**Subject: Recall Campaign UY (04V-592)  
2004-2005 Model Year Volkswagen Touareg Vehicles  
Inspect Rear Outboard Seat Belts and, if Necessary, Install Belt Shortening Clips**

**Subject: Revision to Compliance Recall UY  
2004 – 2005 Model Year Volkswagen Touareg Vehicles  
Inspect Rear Outboard Seat Belts and, if Necessary, Install Seat Belt Clips**

**REVISED** Code: **UY**

**Subject: 2004-2005 Model Year Touareg Vehicles  
Inspect Rear Outboard Seat Belts and, If Necessary,  
Install Seat Belt Shortening Clips**

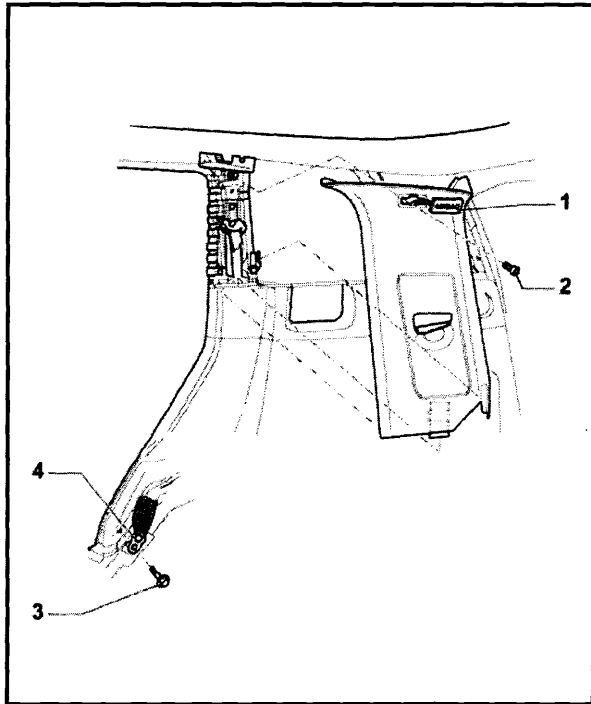
**NEW**

- Pull seat belt through opening and reinstall trim into mountings in body and door seal molding

**Note:** When installing trim, do not press belt height adjustment button

**During installation, attach trim from bottom upwards towards belt height adjuster**
